530-021-15

## ADDENDUM NO. 1

Concordia University -  
Nebraska  
Weller Hall Interior  
Improvements - Phase 3  
800 N. Columbia Ave.  
Seward, Nebraska

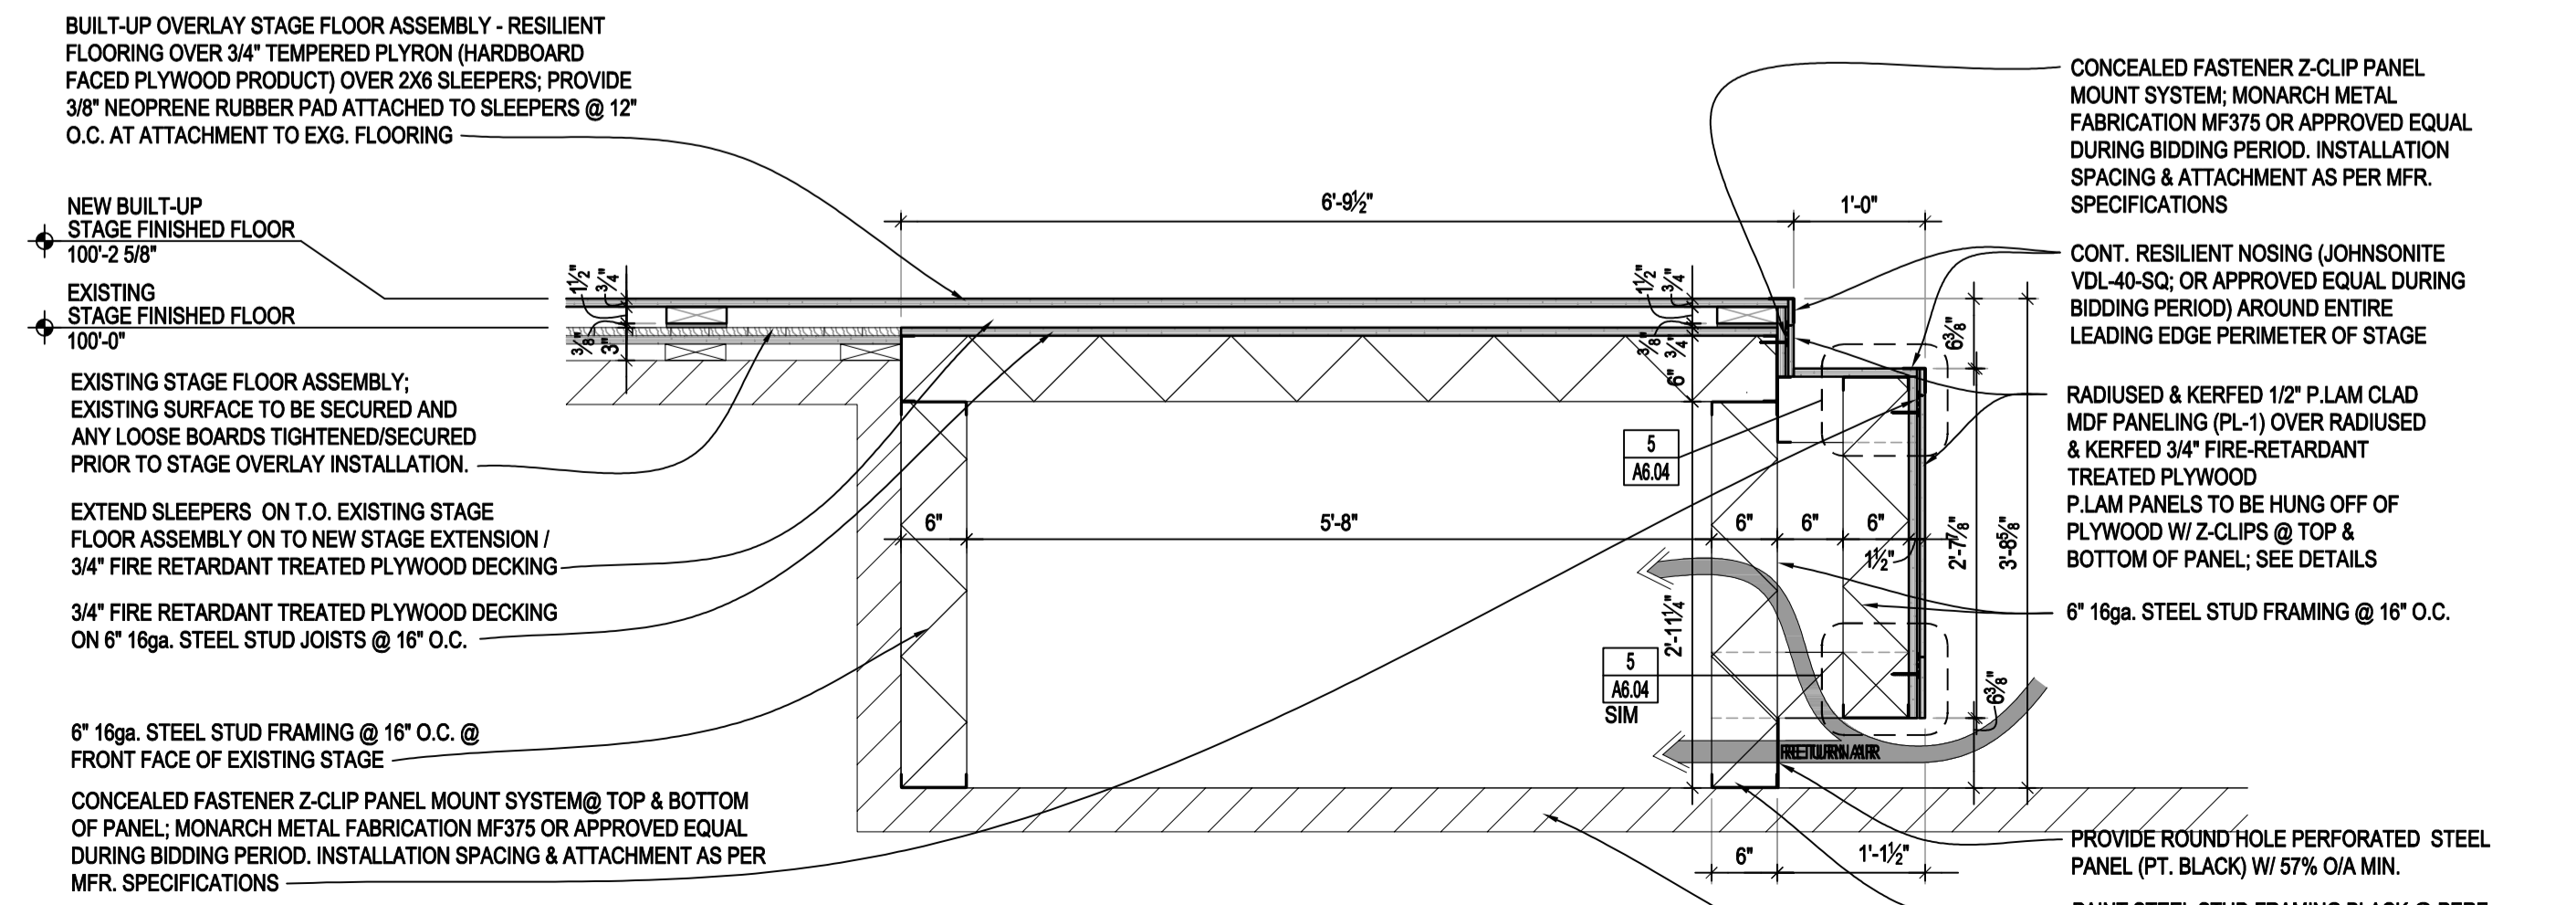
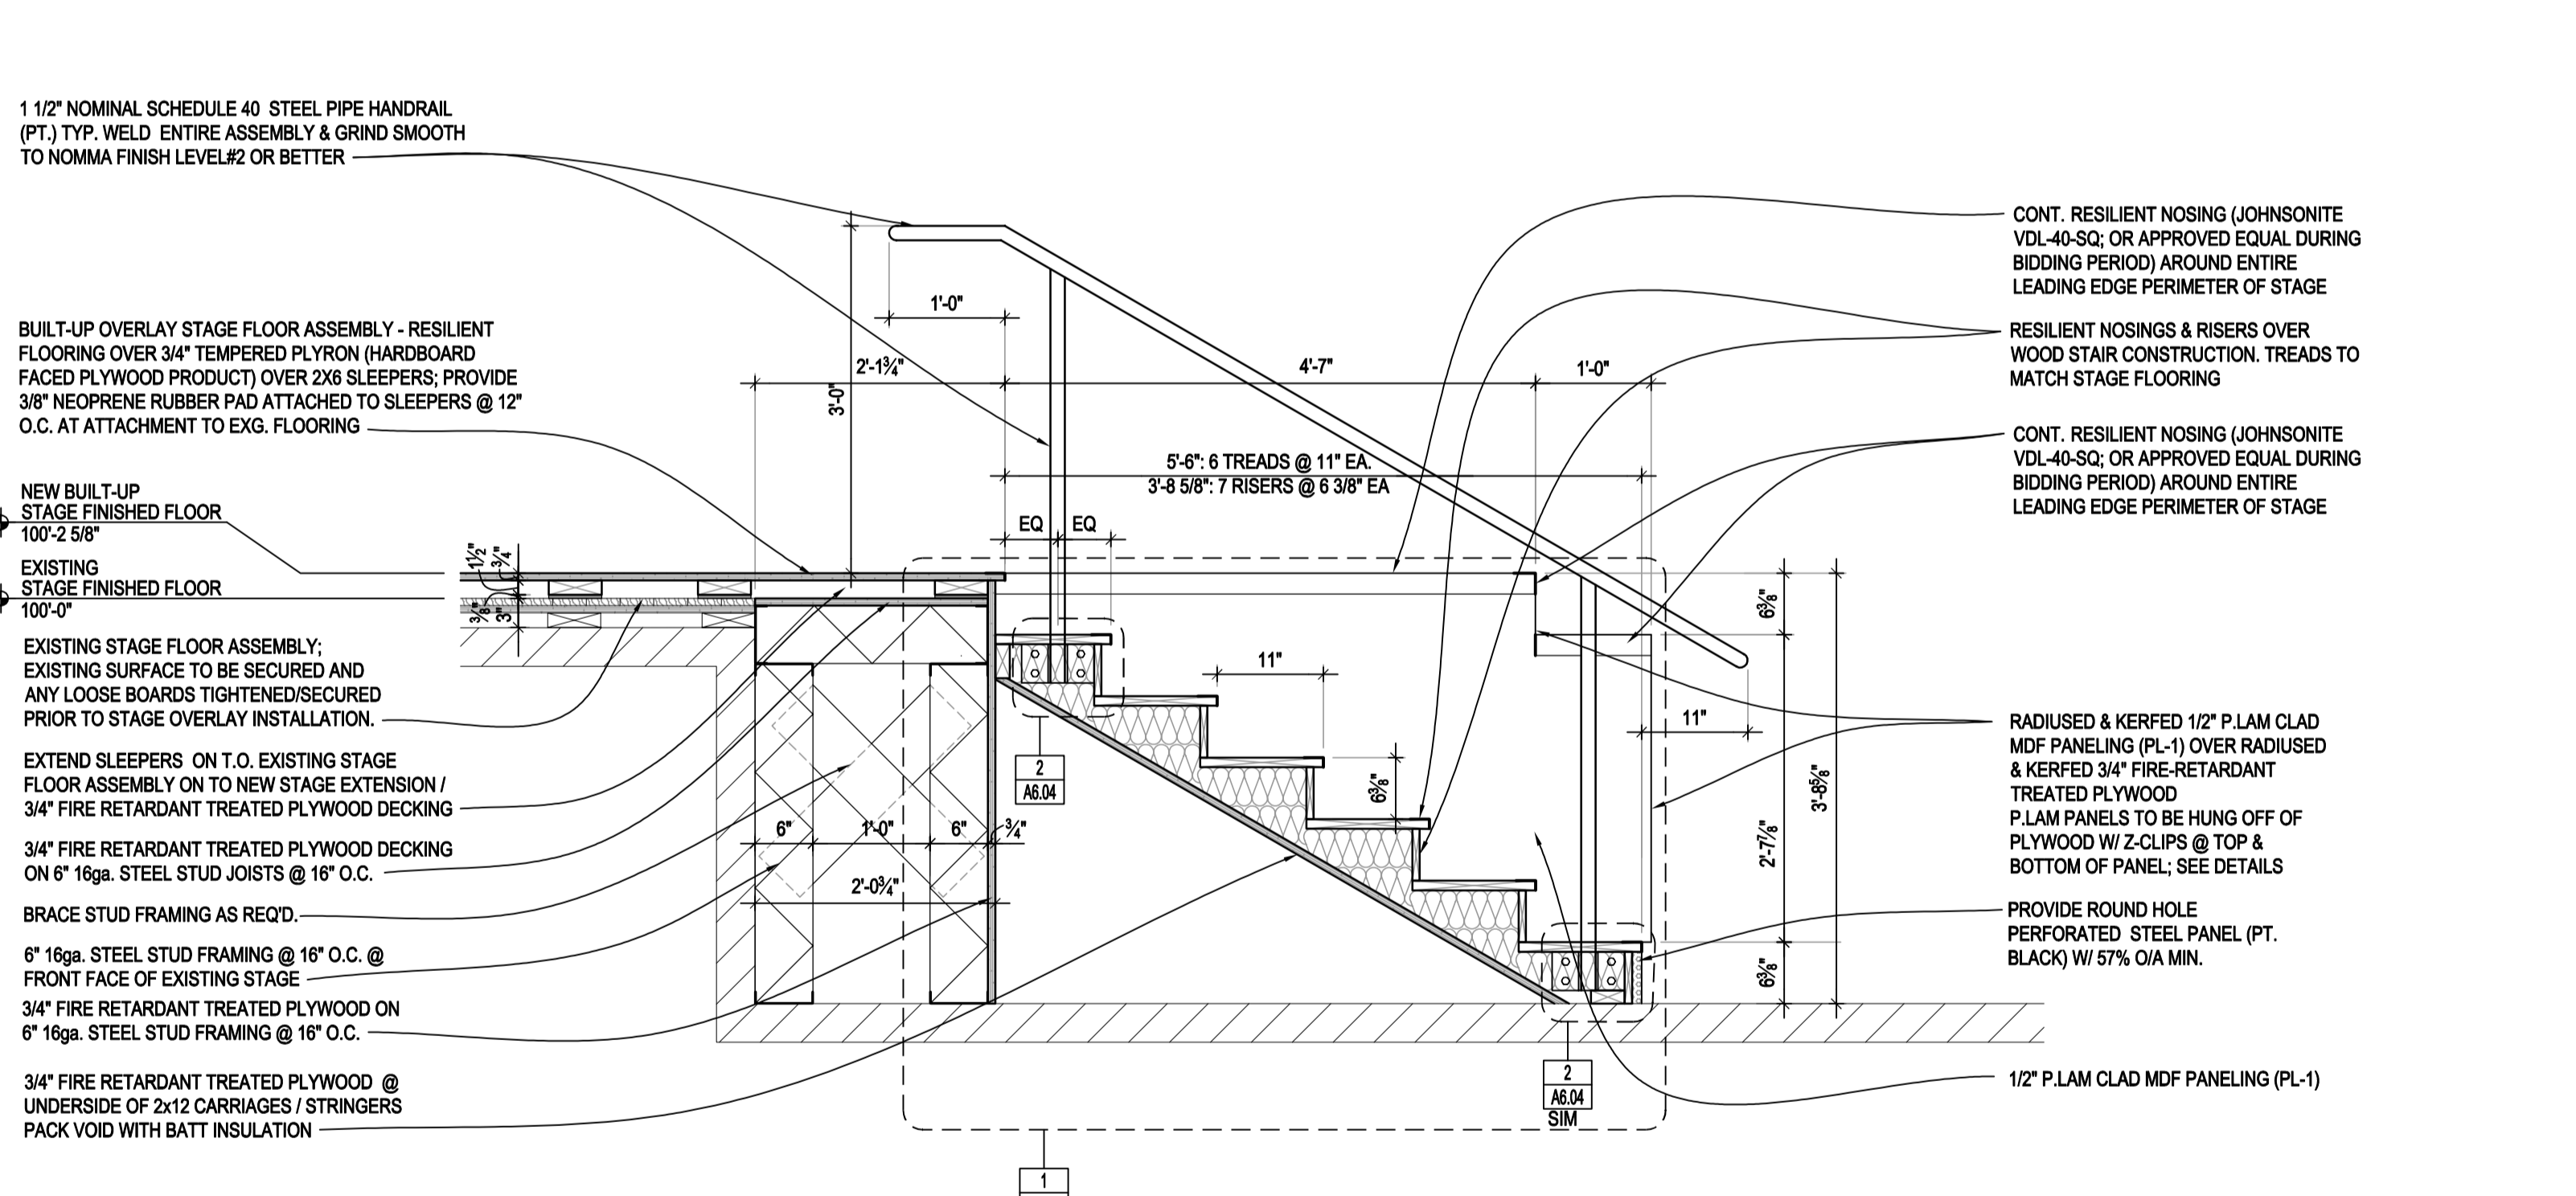
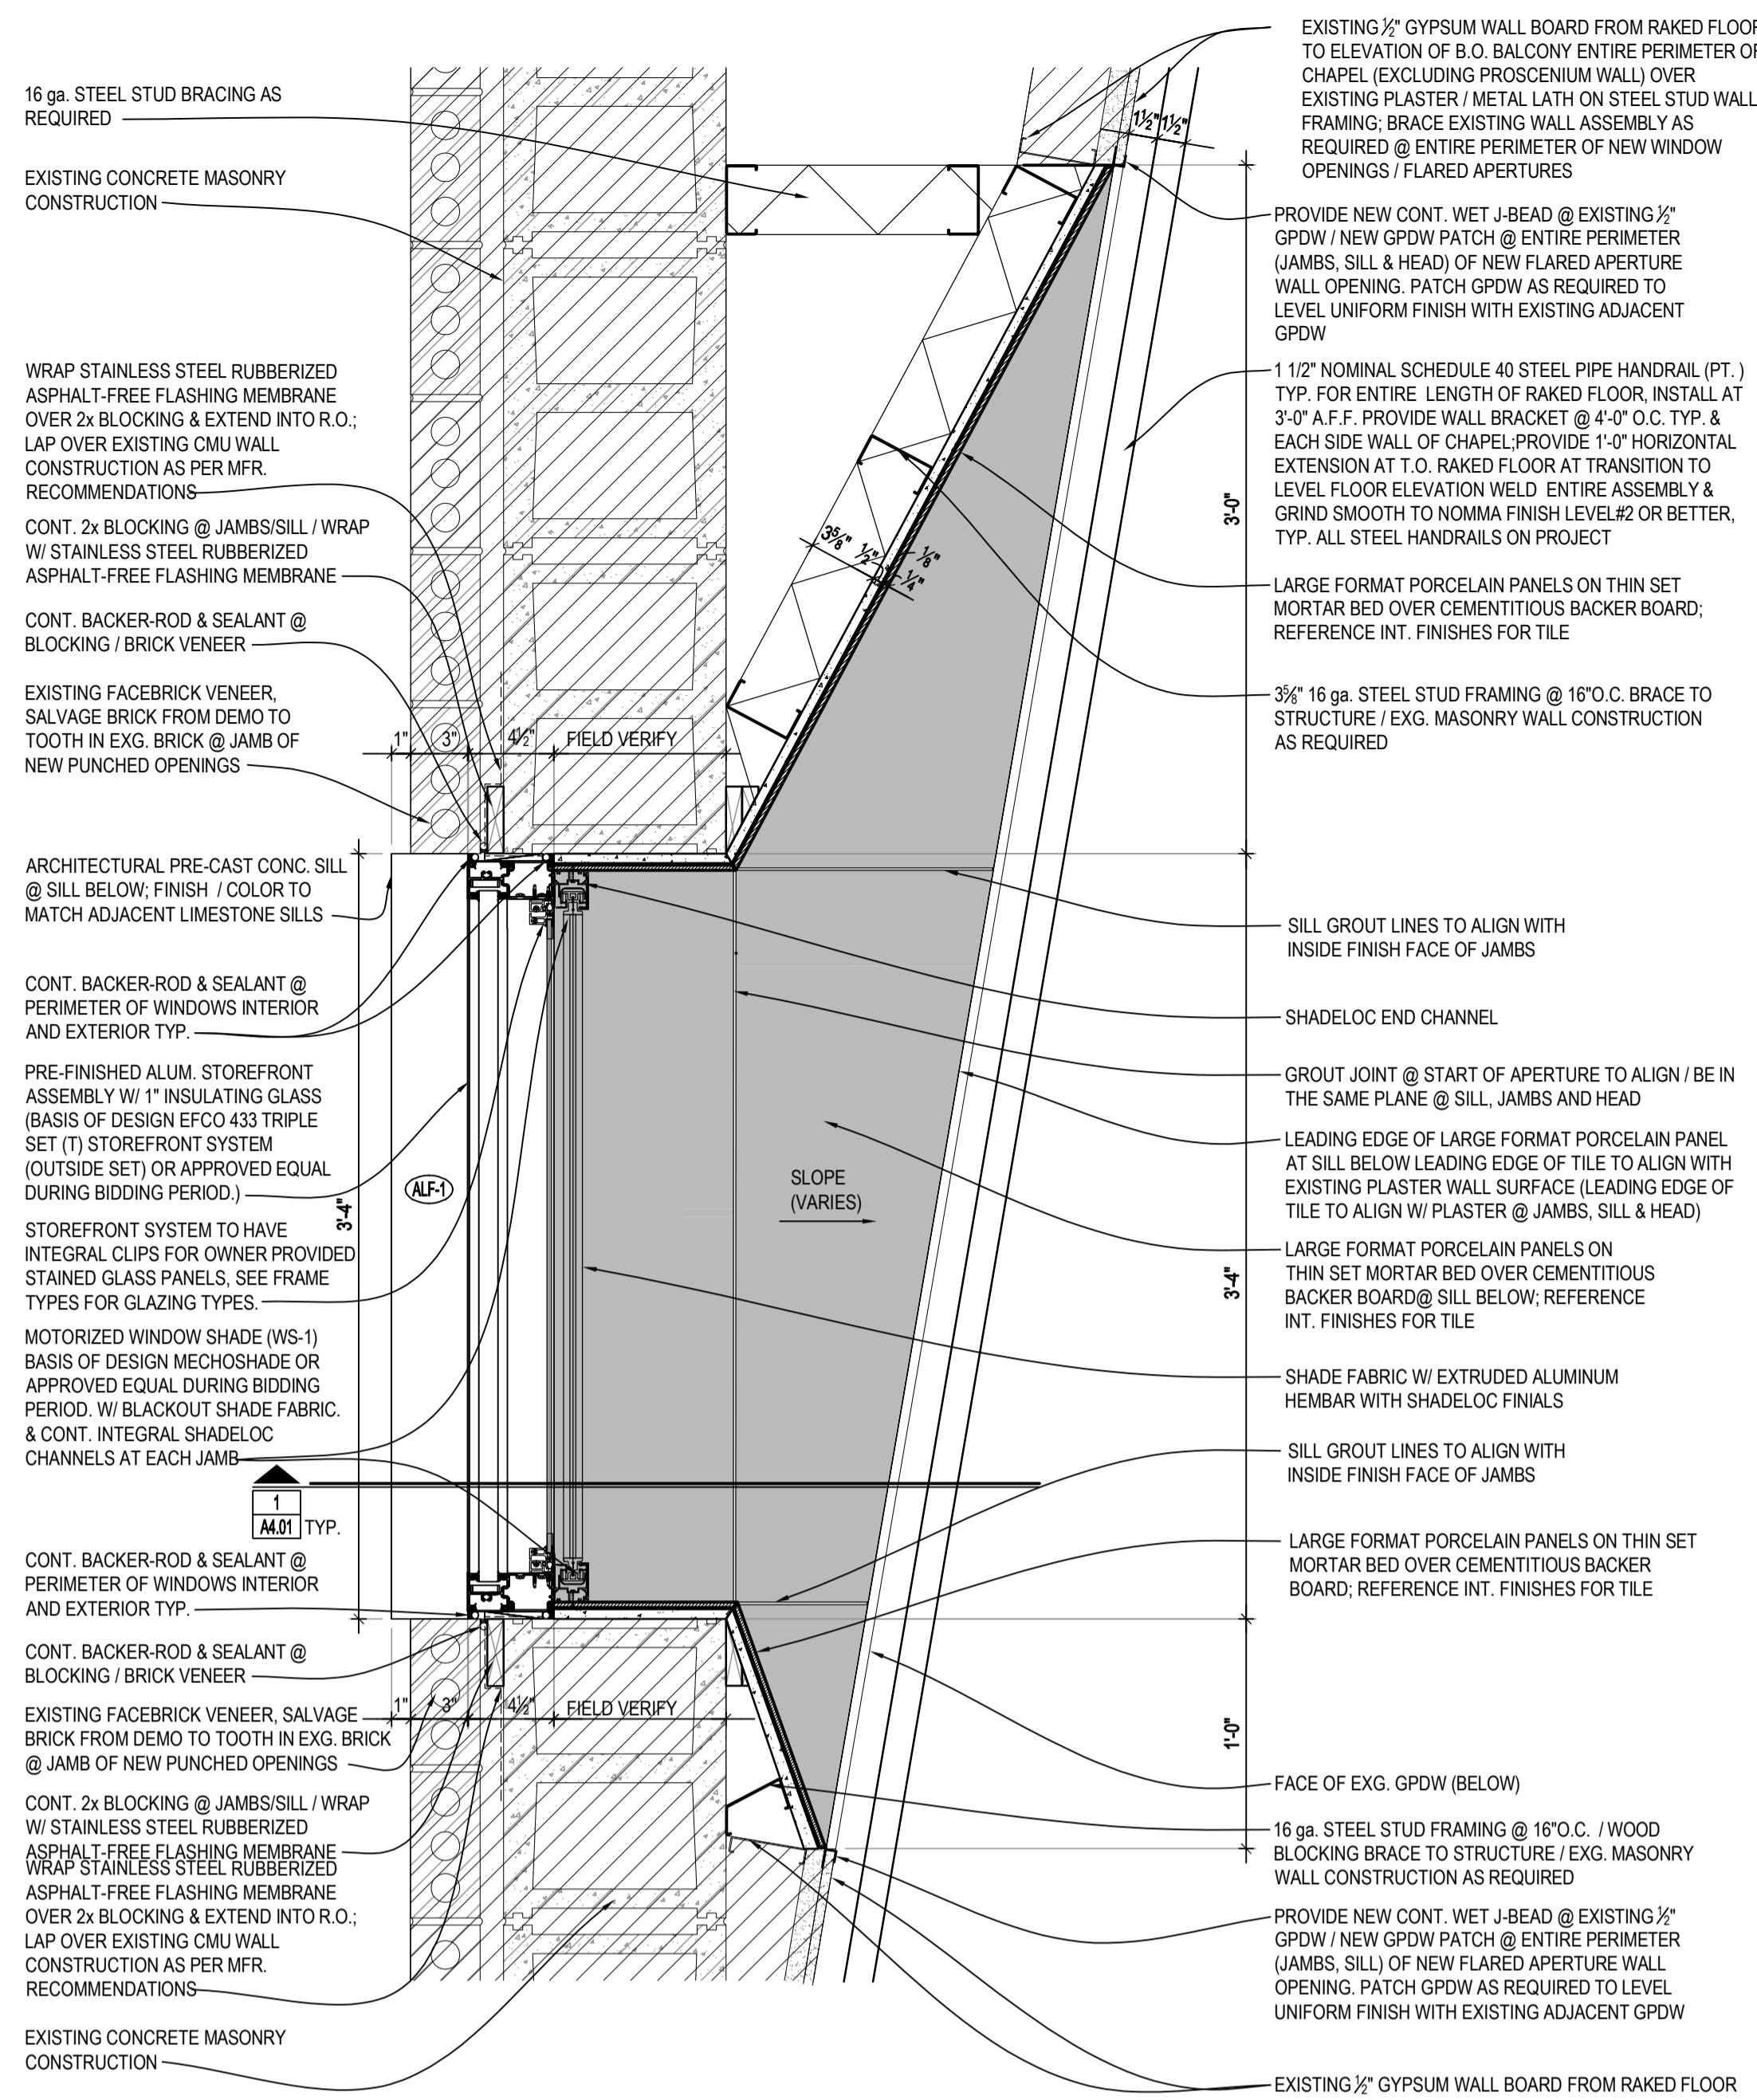
Sheet reissued in its entirety. - Missing Seal, corrected notes & graphical errors  
All stairs leading to the stage from the chapel (stage left, stage right & center) should have RFT-1 (linoleum tile) as the tread surface with matching black resilient risers to match the resilient nosing.
